**INDIAN POINT UNIT 2
CONTAINMENT INSERVICE INSPECTION
FIRST PERIOD EXAMINATIONS**

**Category E-D, Moisture Barrier Examinations
Tab A - Inspection Drawings**

**Category E-D, Moisture Barrier Examinations
Tab C - Listing of Examination Results**

FORM VT-3
 CONTAINMENT INSERVICE INSPECTION
 RECORD OF VT-3 EXAMINATION

VCM-03 Photo 14

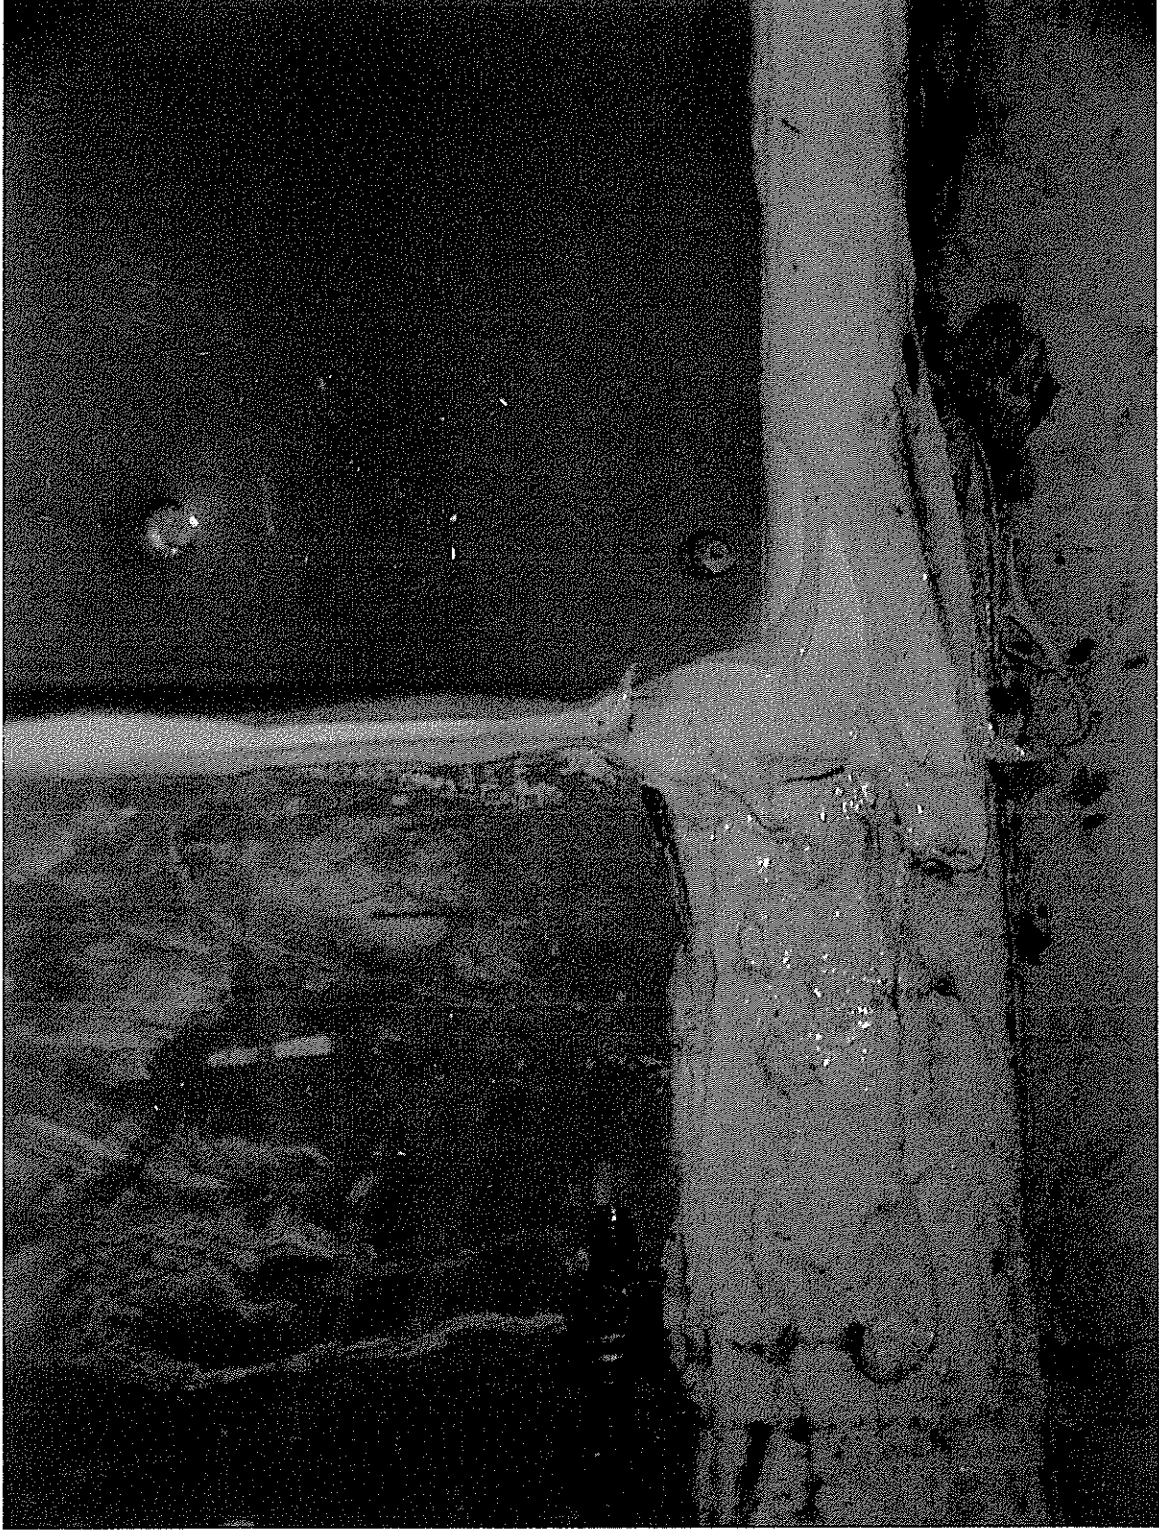
Comments: Recommendation: Repair Crack in sealant.
Repair Area 18" to the left of the crack two holes photo # 16.

No.	Comment	Initials
1	New sealant was applied over old uncleaned sealant. Where	
	The old and the new sealant meet, a separation (crack)	
	in the sealant is evident - NOTE Photo's #14+15	S/W
		5/25/00
	Photo #16 shows two additional areas where the sealant	
	has a separation. These should be repaired.	S/W S/25/00

VCM-04 Photo 20

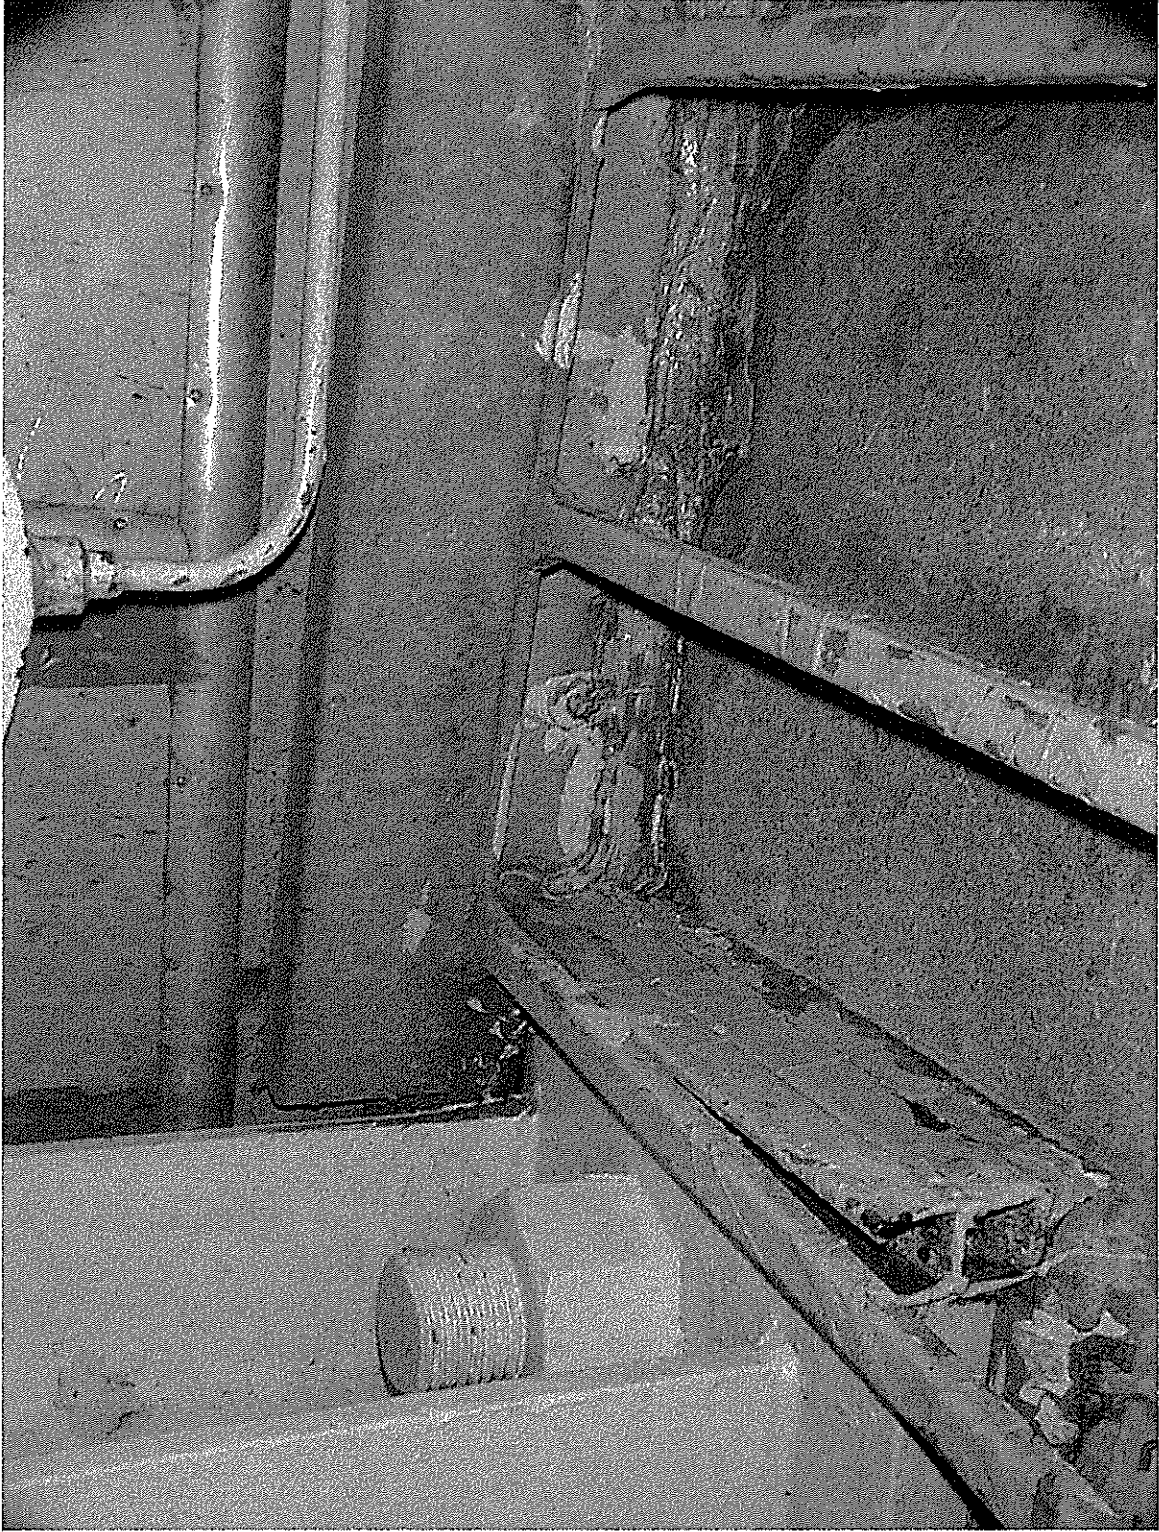
Comments: Recommendation: Repair Sealant.

No.	Comment	Initials
①	DID walking pulling away from moisture barrier (the wall and floor)	
	starting at Column 13 and going 8 feet to the right (towards	
	Column 12). Refer to Photos 20, 21 and 22.	JW
		5/25/00
